Regulatory Compliance Report

Upgrade to Austral Public School

205 Edmondson Ave, Austral NSW 2179

Prepared for:	The Minister for Education and Early Learning
Date:	12.02.25
Revision:	G

7.6. Protection of Openings in External Walls (BCA C4D3, C4D4, C4D5 (previously C3.2 / C3.3 / C3.4))

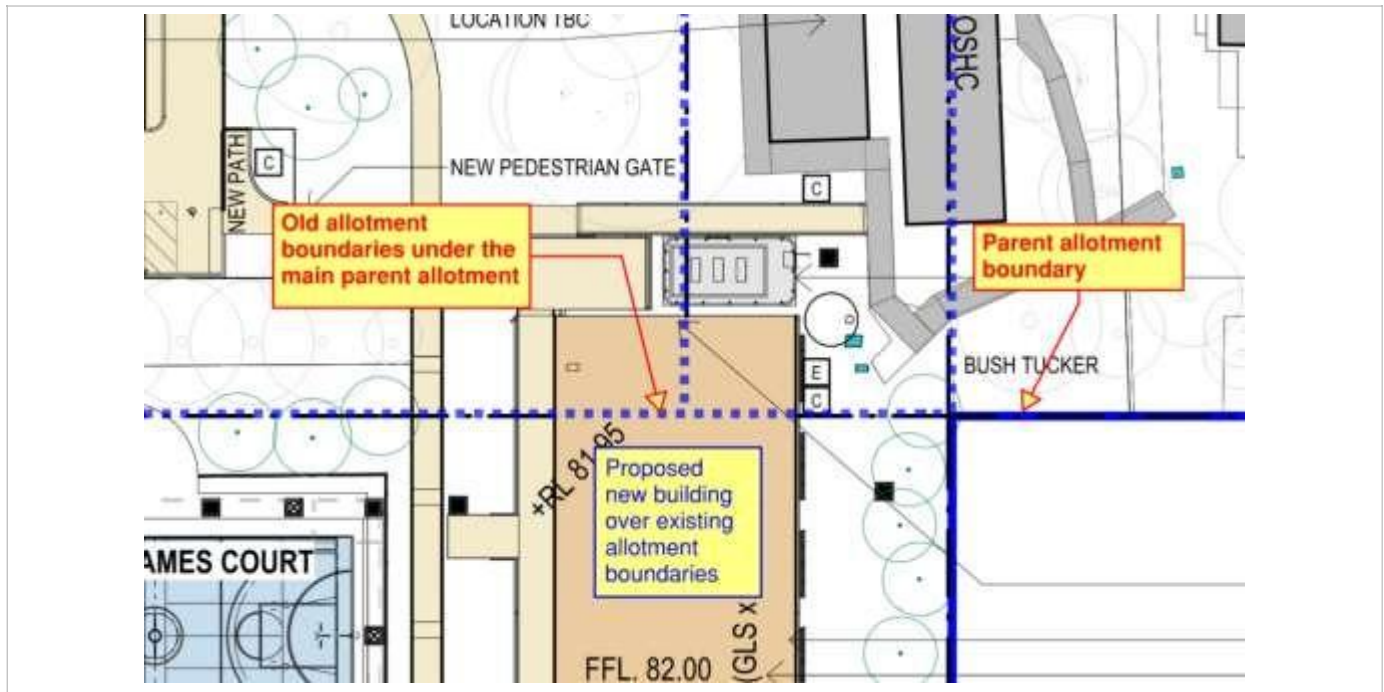
The prescriptive provisions of the BCA stipulate that any external opening within 3m of the boundary, within 6m of the far boundary of a road, river, lake or the like that adjoins the allotment, or within 6m of another building on the allotment requires protection by -/60/- fire rated construction, or externally located wall wetting sprinklers.

Due to the proposed building being built over 3 allotments due to not being amalgamated under the parent allotment, this technical creates non-compliance with the BCA under this clause. The non-compliances are as follows:

- FRL requirements building within 3m from the boundary,

- Protection of openings within 3m from the boundary.

The technical non-compliance above is to be addressed as a performance solution by the Fire Safety Engineer using BCA Performance Requirements C1P2 and C1P8.

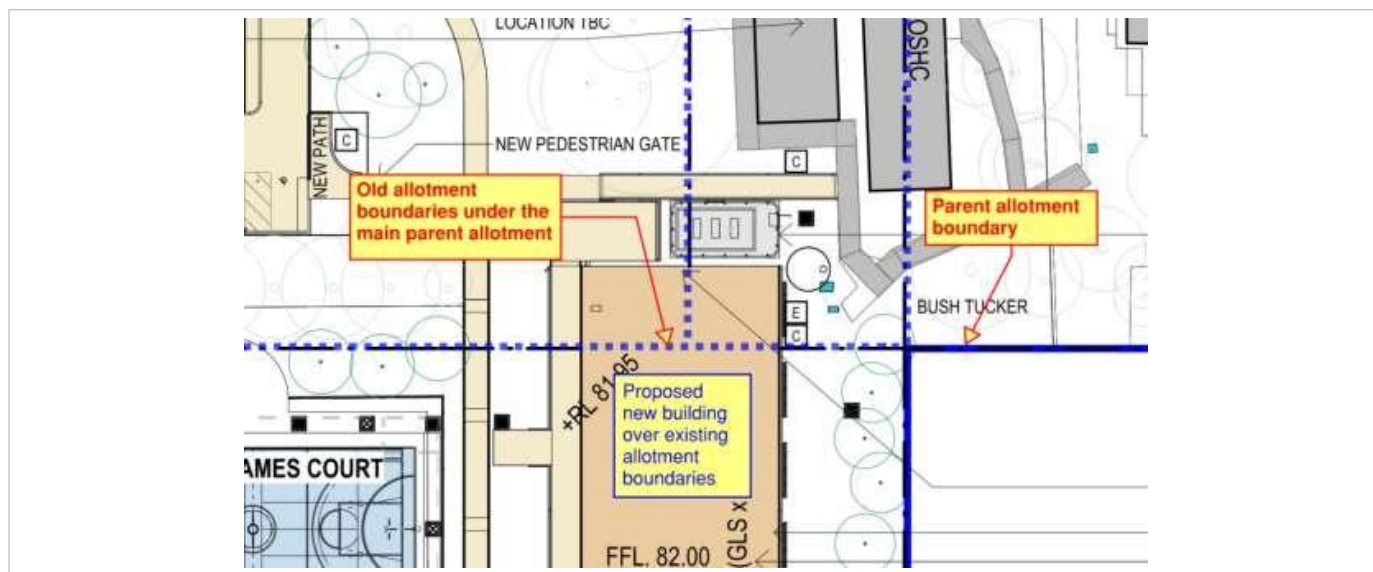
In addition, technical non-compliance exists for the proposed new building due to the existing allotments have not been amalgamated into the one-parent allotment, therefore, a performance solution by the fire engineer is required for shared services over different allotments.
